# Wisconsin Department of Transportation

**Proposal #5: ID 5310-02-70, WISC 2015 084  
 Spring Green – Madison  
 CTH KP to Westview Ct,  
 Village of Cross Plains  
 USH 14  
 Dane County**

This is Addendum No. 1, which provides for the following:

**ADDENDUM NO. 1**

Addendum No. 1  
ID 5310-02-70  
Revised Sheet 58  
January 20, 2015

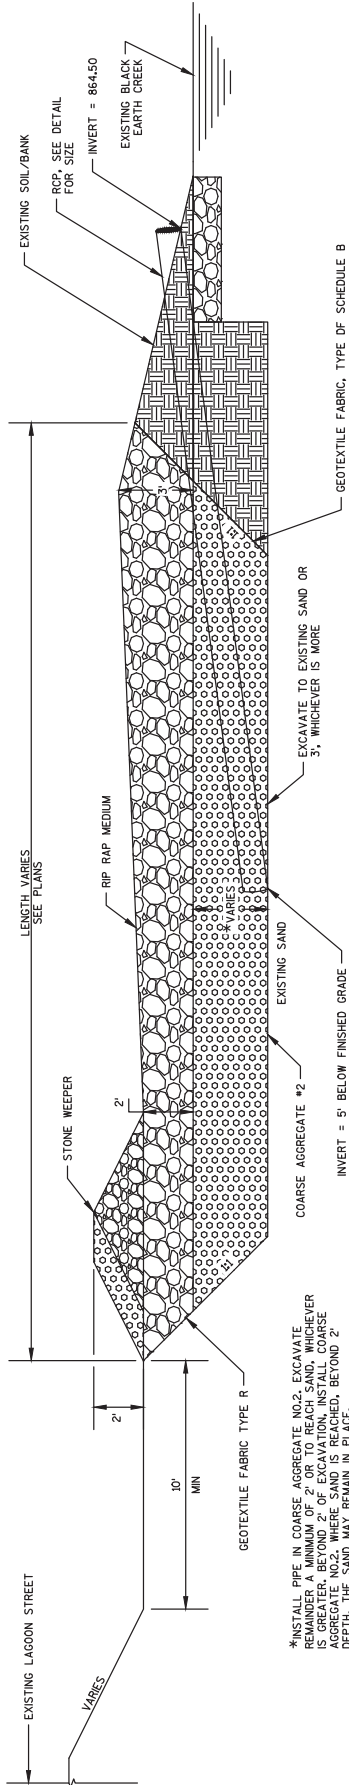
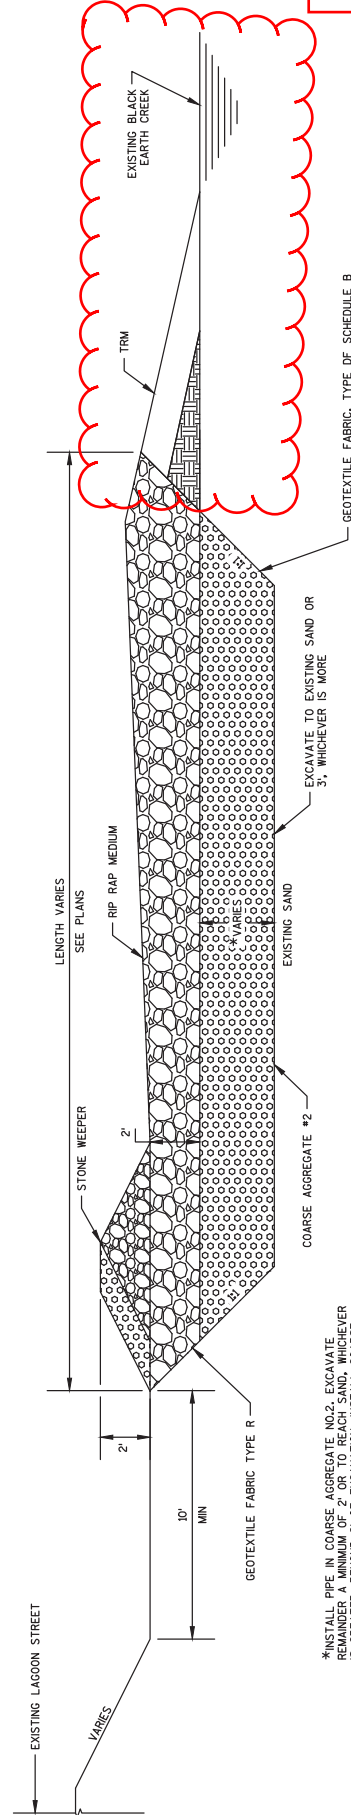
Revised Plan Sheets	
Plan Sheet	Plan Sheet Title (brief description of changes to sheet)
	<b>ID 5310-02-70</b>
58	Construction Detail (grade change)
60	Construction Detail (grade change)
112	Storm Sewer Plan USH 14 (added temporary pipe)
235	Miscellaneous Quantities (updated quantity)
237	Miscellaneous Quantities (updated quantity)
238	Miscellaneous Quantities (updated quantity)
251	Miscellaneous Quantities (updated quantity)
261	Miscellaneous Quantities (updated quantity)
599	Cross Sections (grade change)
601	Cross Sections (grade change)
602	Cross Sections (grade change)
603	Cross Sections (grade change)
	<b>ID 5310-02-73</b>
4	Plan and Profile: Sanitary Sewer and Water Main (minor edits)
7	Plan and Profile: Sanitary Sewer and Water Main (minor edits)
18	Miscellaneous Quantities (updated quantity)
19	Miscellaneous Quantities (updated quantity)
24	Miscellaneous Quantities (updated quantity)

Addendum No. 1  
 ID 5310-02-70  
 Added Sheet 442A  
 January 20, 2015

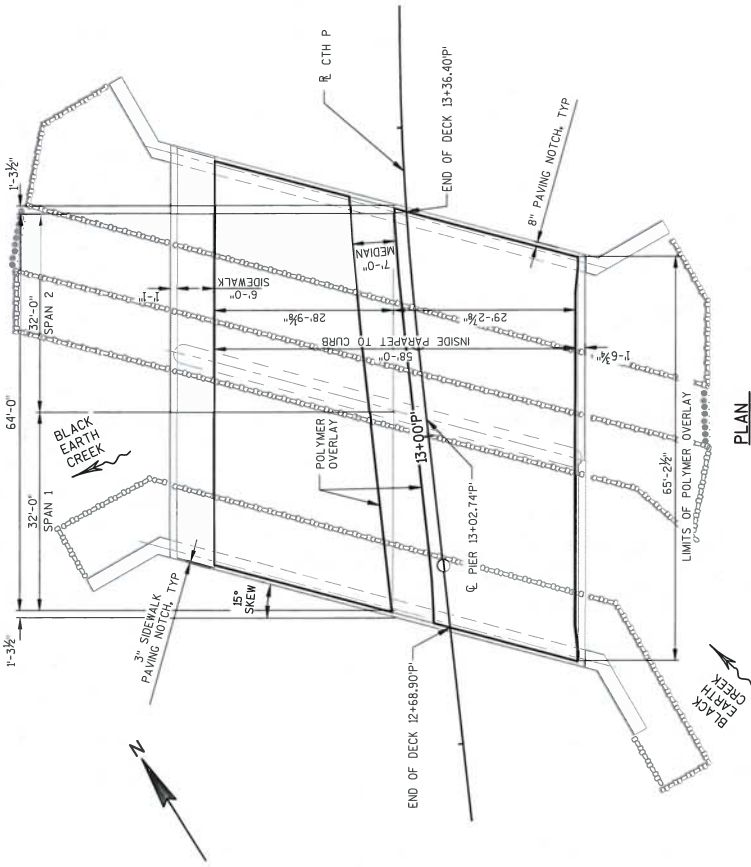
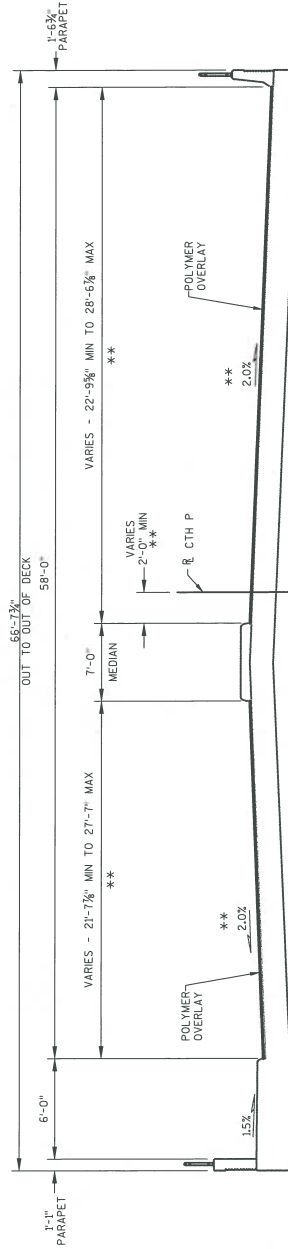
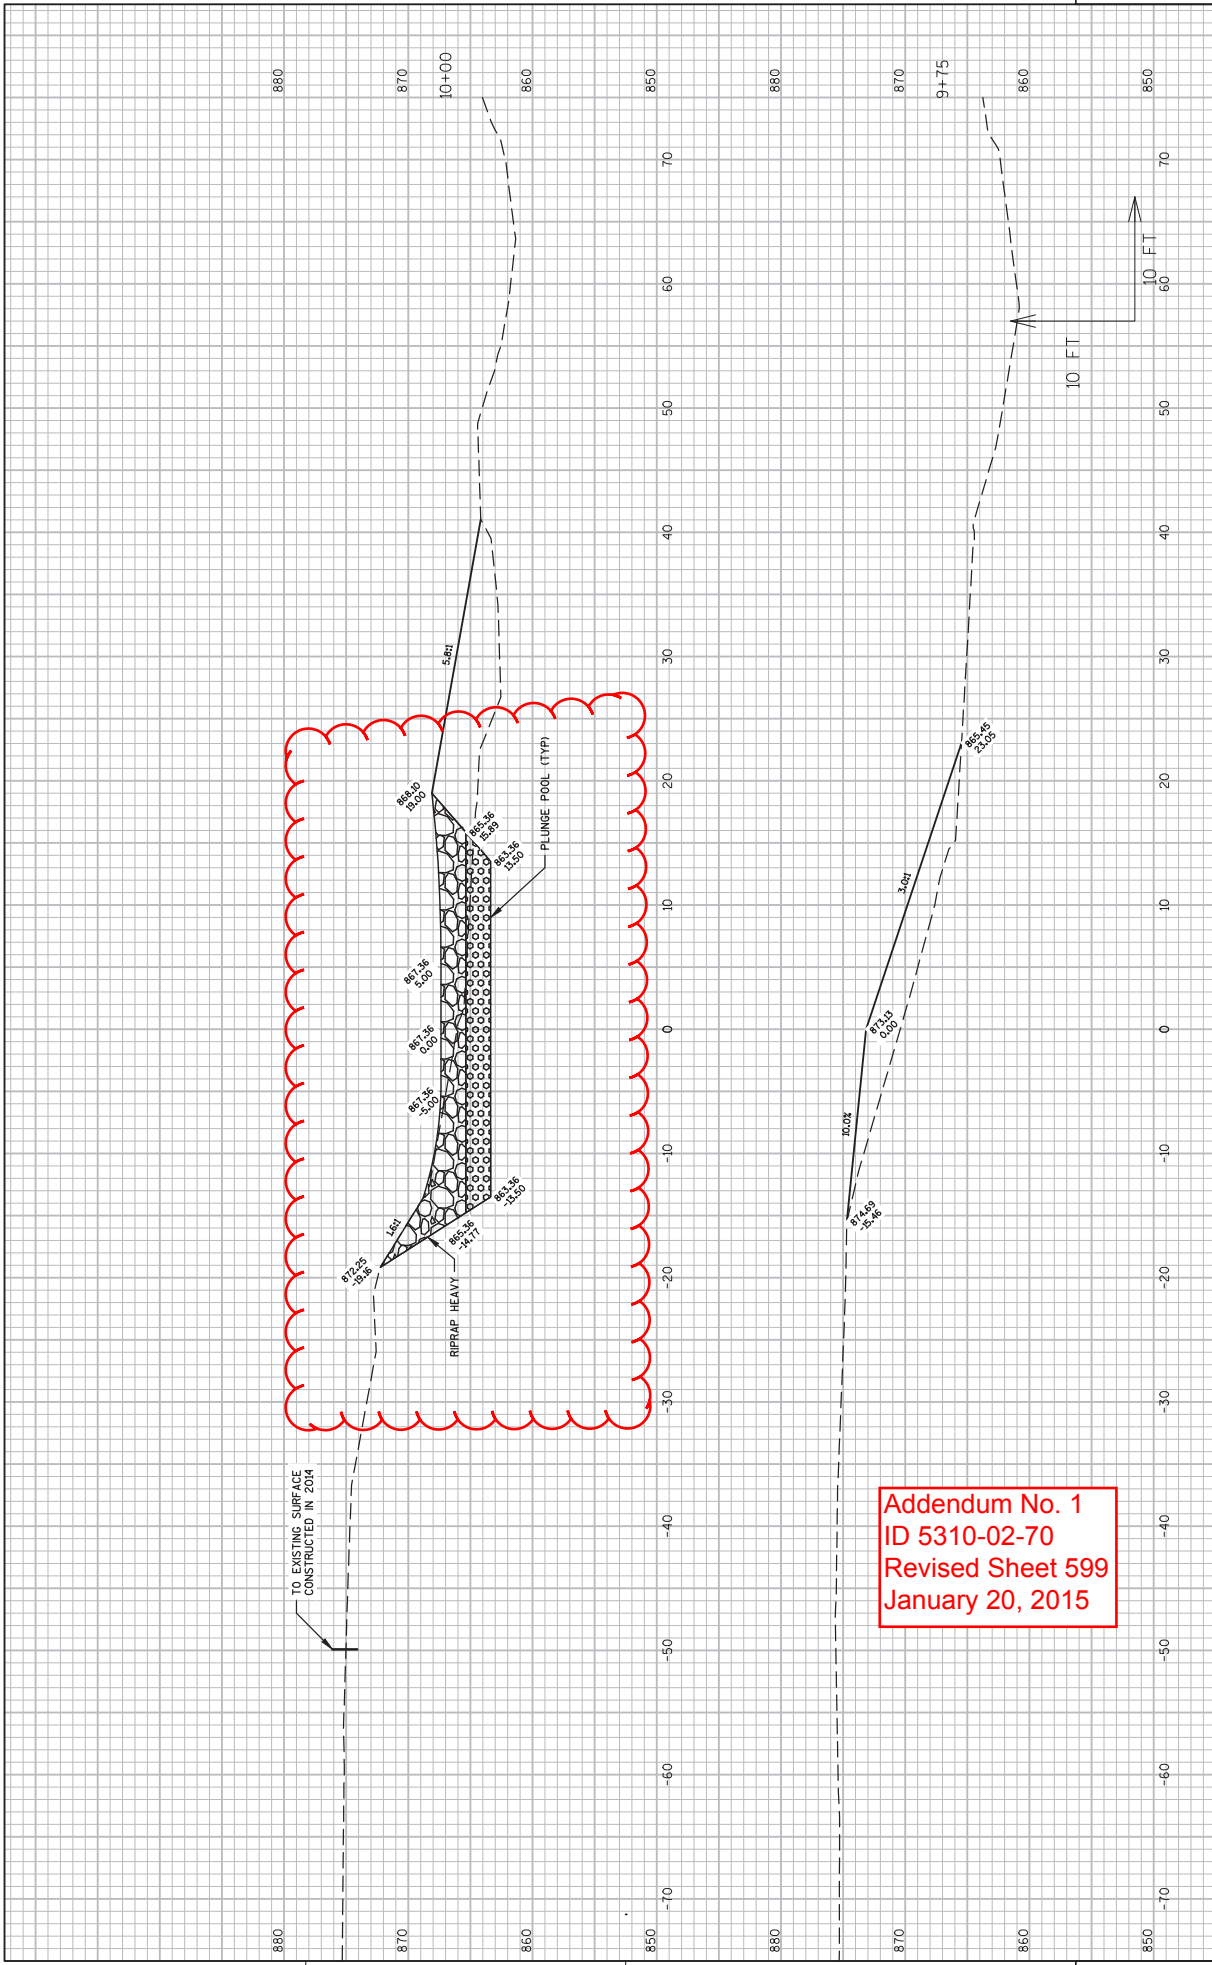
Added Plan Sheets	
Plan Sheet	Plan Sheet Title (brief description of changes to sheet)
	<b>ID 5310-02-70</b>
442A	B-13-646 Polymer Overlay (added structure plan sheet)
